PROPOSED NEW LAVATORIES  
- FOR -  
SHORT & MCDONALD  
- 927 UMGANI RD -  
SCALE 1"=4'

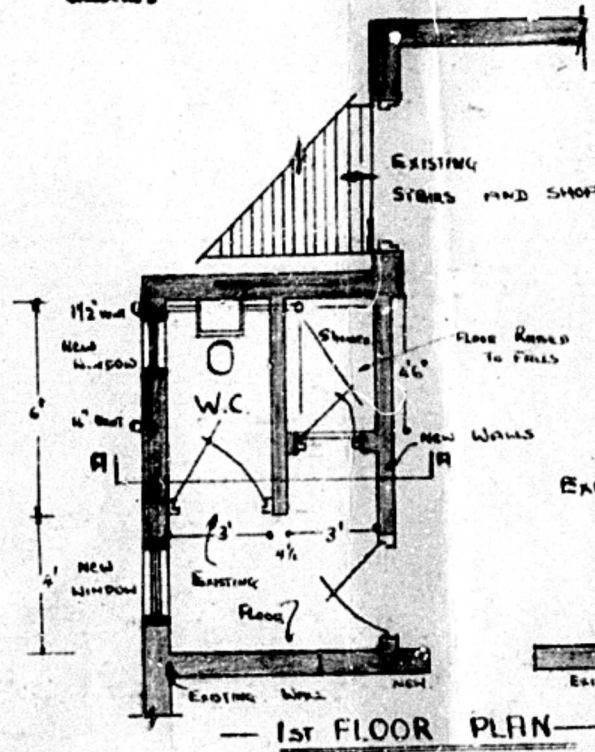
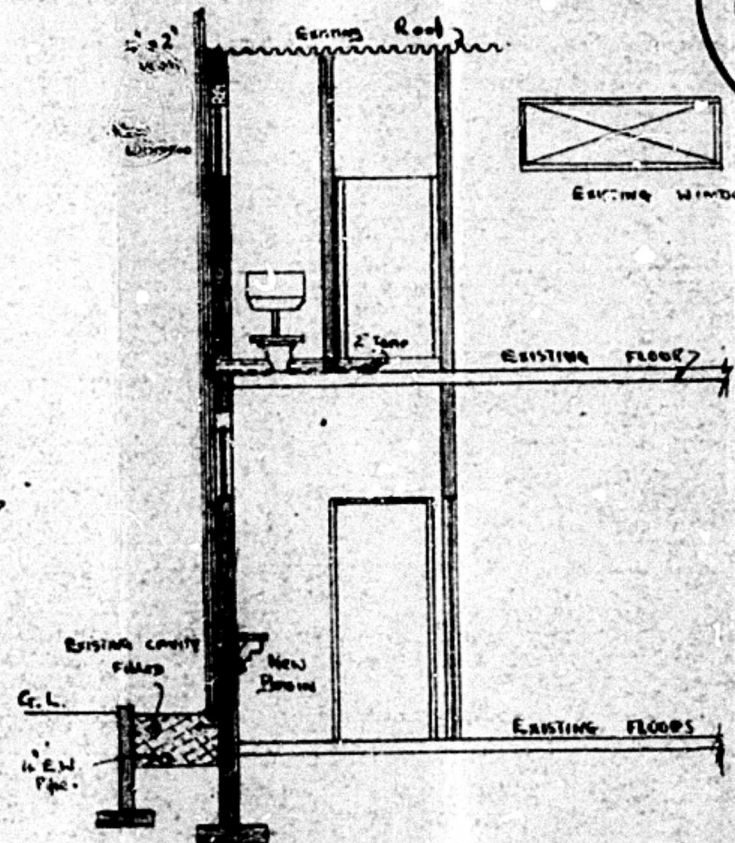
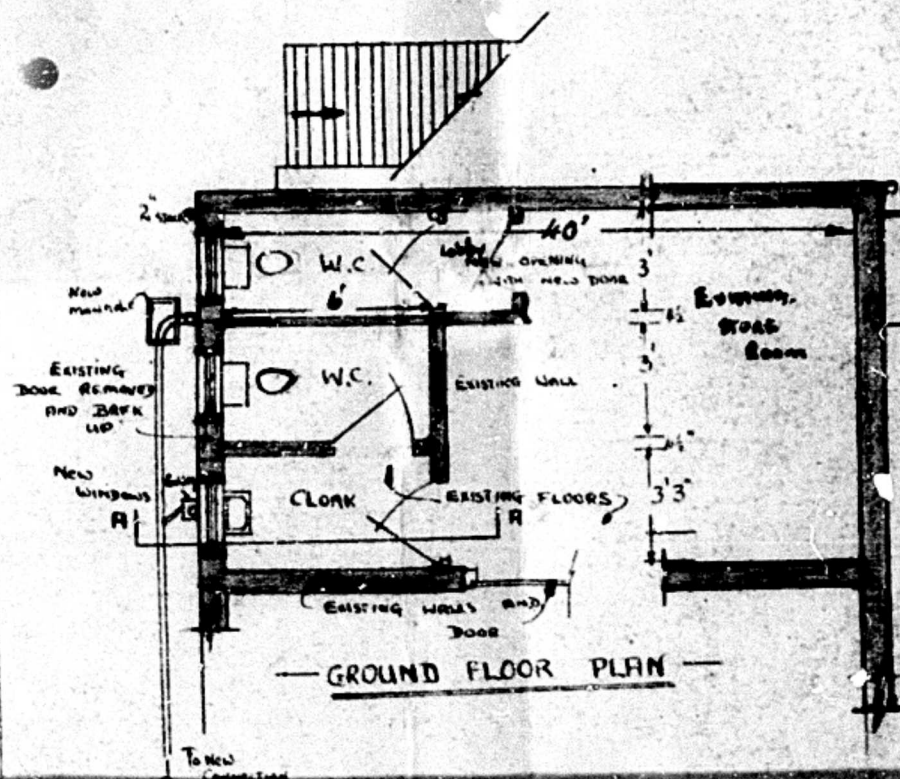
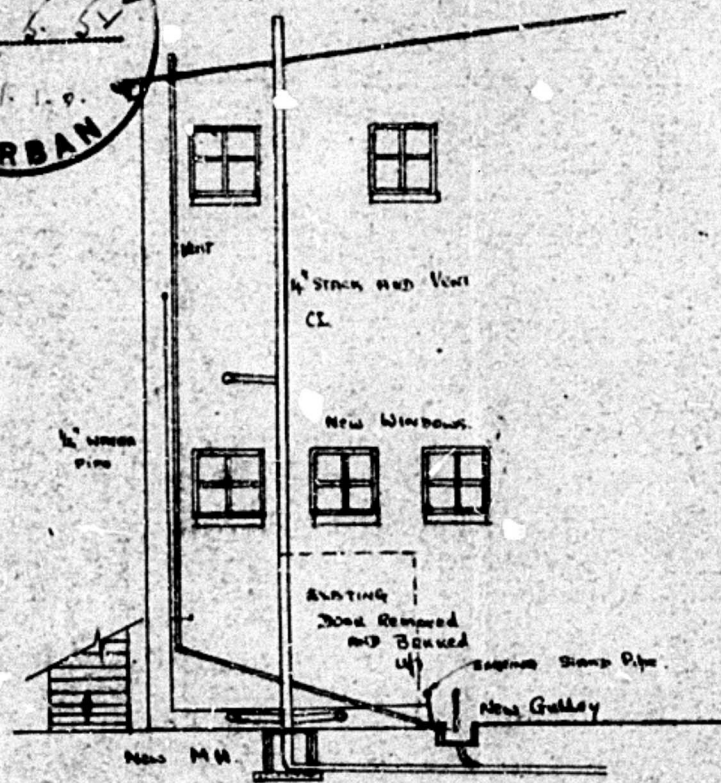
Not a Cold Water to be  
Required to Shoppers &  
Business

CONNECTION FEE  
FULL COST
